# REVERSING MOTION

## PROPOSALS FOR VRU PROXI

# OPTIMISATION FOR SEMI TRUCKS

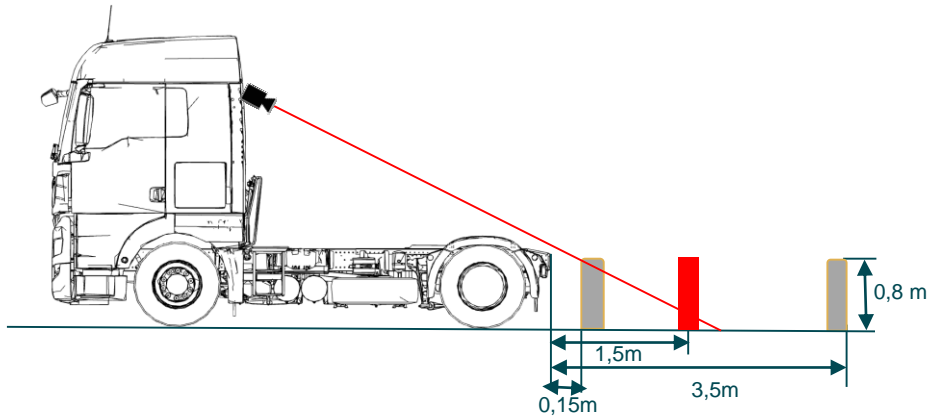
Test objects in row 2 must be seen completely and camera must be placed in the rear

- View from backside of the cabin provides better view of VRU at solo semi truck rear
- Test objects in row 2 shall at least be XX % visible (e.g. 50%)
- Increase test objects to 100cm for semi trucks
- Move test objects 15cm to the back
